Amendments to the Drawings

Remarks/Arguments

FIG. 5
PRIOR ART

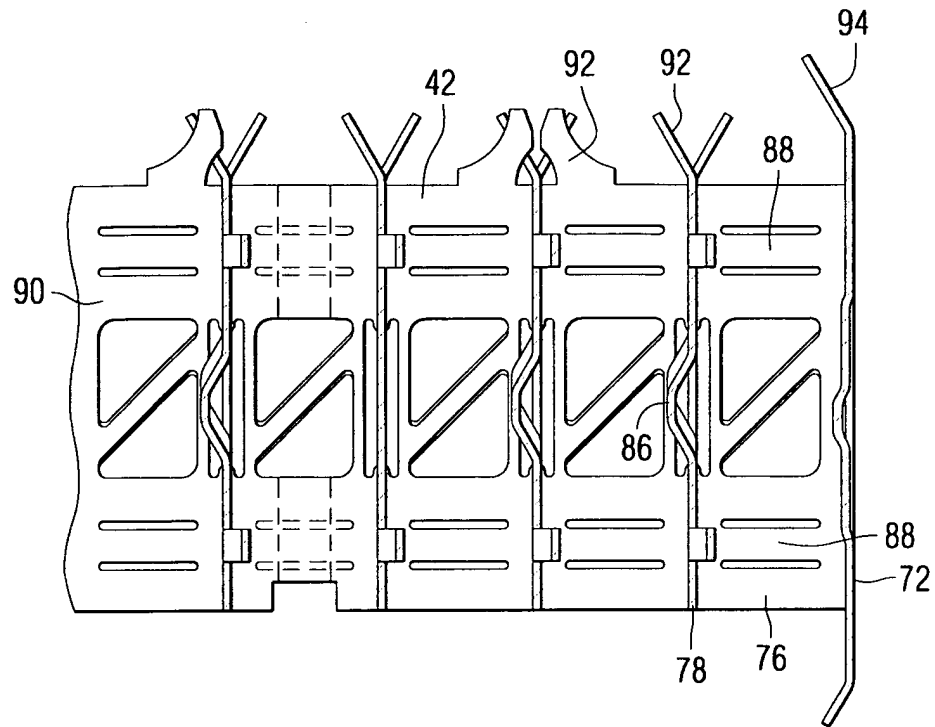
In Section 4 of the Office Action Fig. 5 was objected to for not having a prior art legend. The enclosed amendment to Fig. 5 should cure that defect. Accordingly, it is respectfully requested that the objection to Fig. 5 be withdrawn.

The attached sheet of drawings includes changes to Figure 5. This sheet, which includes Figures 5 and 7, replaces the original sheet including Figures 5 and 7. In Figure 5 a "PRIOR ART" legend has been added.
